Drain-Improvement: SUTTON PLACE DRAIN- HUNTINGTON CHASE

RE: Sutton Place Drain-Huntington Chase Arm

Re: Sutton Place Draim - Huntington Chase Arm

CONSTRUCTION RECORD DRAWING FOR STORM Sutton Place Section 2

Map Correction-Field Verification

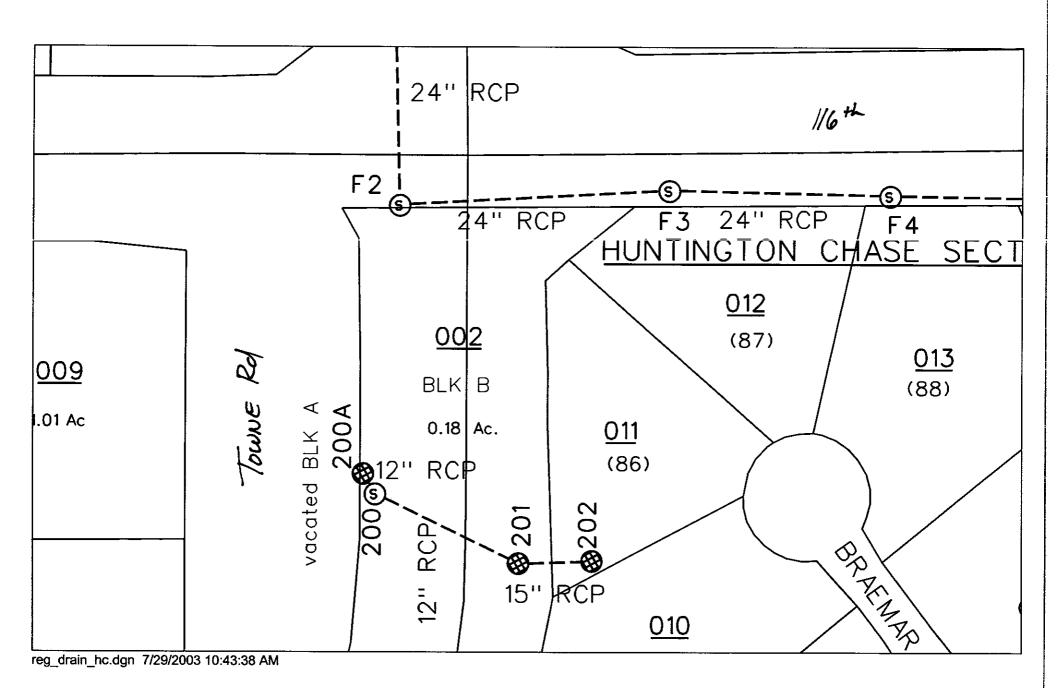
FIELD Check was performed due to the intersection improvements completed at 116th street i Fowne Road. There was an additional structure set in the ROW for Towne Road. This accounts for the addition of 9 freet of 124 RCP to the arains length. The structure set was an inlet to pick up surface water in the ROW.

13,031 Ft.
